**DESIGN COMMISSION
MEETING**

Pg. 4 **A. PLN-2021-02623 - Walmart Remodel**

PROJECT NAME Walmart Remodel	FILE NUMBER PLN-2021-02623	HEARING/MEETING DATE October 13, 2021
STAFF CONTACT Mary M Reinbold	PROPERTY OWNER WALMART REAL ESTATE BUSINESS TRUST	APPLICANT Zachary Stone on behalf of Galloway & Company, Inc.
ADDRESS 19205 State Route 410 E	TAX PARCEL(S) 7000040102	
ZONING DESIGNATION Midtown Core	LAND USE DESIGNATION Commercial-Core	SUBAREA Midtown
BRIEF SUMMARY OF REQUEST The applicant proposes an outdoor remodel to accommodate additional pick up/online order customers.		
COMPREHENSIVE PLAN CONSISTENCY The proposed development is consistent with the adopted comprehensive plan, <i>Bonney Lake 2035</i>, specifically implementing Goal CD-2 to develop dynamic and vibrant centers.		
DEVELOPMENT CODE CONSISTENCY The proposed development is a permitted use in the Midtown Zoning District and is consistent with applicable development regulations provided that the recommended conditions of approval are imposed on the project.

RE: Design Review – PRE-2021-00181 – Walmart Online Pick-up Service

Figure 3 - New parking strip, red area requires landscaping

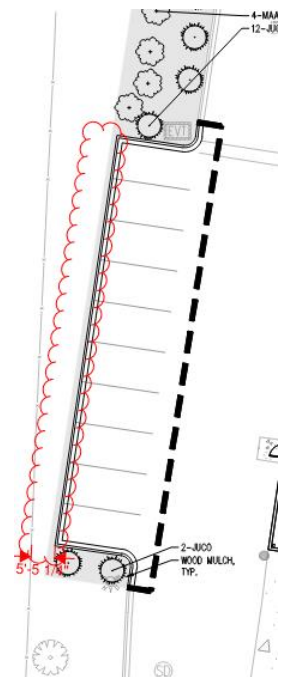
BLMC 16.68.090(3) establishes that the current landscaping standards shall only apply to the portions of the vehicular use area to be amended by the proposal. A five foot wide type 3 landscaping buffer shall be required along the newly proposed parking spaces to the southwest of the new pick up area. Alternatively, the applicant can supply documentation which demonstrates the existing landscape meets the standard. The applicant’s proposal includes the use of bark mulch, mulch must comply with BLMC 16.68.030(H). Two landscaped islands are being amended. The applicant’s proposal conforms with BLMC 16.68.090(E). The applicant may choose to

amend the submitted landscaping plan to incorporate a pedestrian connection similar to detail C in BLMC 16.68.090(E)(4).

1. The applicant shall submit a revised landscaping plan as part of a complete building permit application to modify the required landscaping buffer around the new parking stalls and utilize the City of Bonney Lake adopted landscaping details and notes.
2. Verification of compliance with BLMC 18.39.030, lighting doesn't not spill onto adjacent properties, and lighting is provided in all loading, storage and circulation areas with cut-off shield. This compliance shall be provided through photometric plan and a letter of compliance at before final inspection. Lighting shall be dark sky compliant.
3. The applicant shall submit a revised site plan as part of a complete building permit application to modify the proposed pedestrian pathway from the eastern edge of the development to the front entrance.
